ADDITIONAL FOUNDATION
INVESTIGATION REPORT -
W.J. 61-F-16 -- W.P. 119-58

Re: Darlington Twp. Bridge No. 12,
Waverly Road Underpass at Hwy. 401
Intersection -- District No. 7.

REVIEW OF PRELIMINARY PLAN -

W.P. 119-58,
Darlington Twp. #12
Hwy. 401 - Dist. #7.

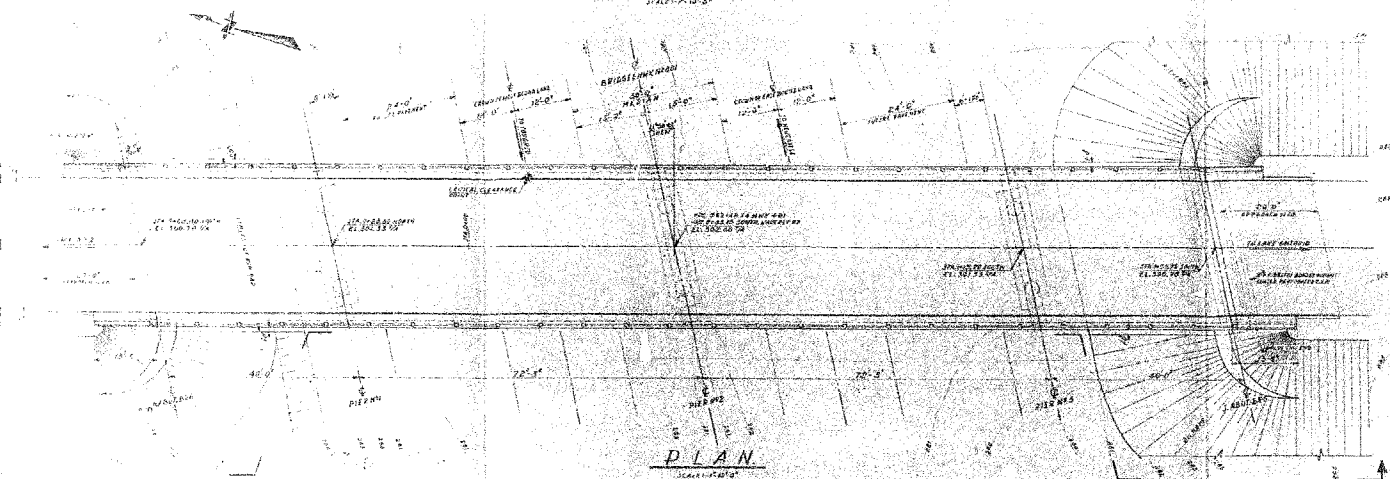
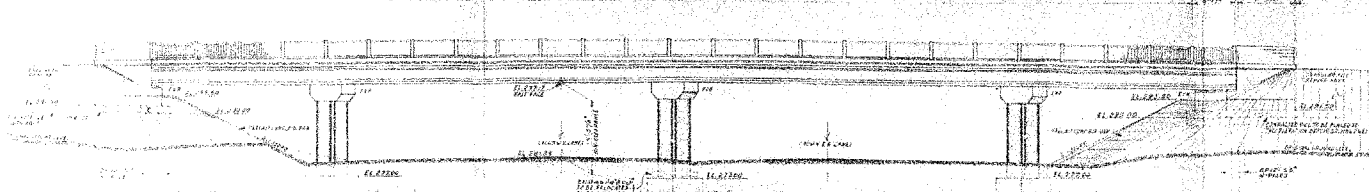
On the Preliminary Plan, Drawing D-4838-P1, a four-span continuous structure is shown. This proposed structure can be founded on spread footings. For footings of an average width of 6 - 8 ft., the following elevations are recommended -

Spill-through type abutments are shown on the above mentioned drawing. If, as an alternative, piles are considered, they should be driven through the embankment fill down into the

Because of the convenient subsoil conditions, it is recommended that a two-span structure with retaining wall type abutments be also considered as a solution. For approach fills, no stability problems are anticipated.

In reviewing the preliminary bridge plans for the two above mentioned sites, we have found that the designer has not followed our recommendations regarding the foundation bottom elevations.

North Abutment	- Sta. 0+68.80 - North	273.0'
South Abutment	- Sta. 1+55.70 - South	274.0'
Pier No. 1 - Sta. 0+28.80 - North	273.0'
Pier No. 2 - Sta. 0+43.45 - South	274.0'
Pier No. 3 - Sta. 1+15.70 - South	274.0'

For the above elevations a safe load of 3 T/sq.ft. for the abutments and 4 T/sq.ft. for the piers, can be used.

dense till stratum. It is anticipated that the piles will meet practical refusal when they penetrate a few feet into the dense till stratum. Six blows per inch penetration for the last two feet can be considered as practical refusal. Such piles can be safely loaded with 30 tons per pile.

Difficulties can be experienced during pile driving if the embankment fill is very well compacted; therefore, steel 'H'-piles are recommended. The length of the piles can be computed on the assumption that they will be driven about 3 ft. below the elevations given for the bottom of the abutment footings.
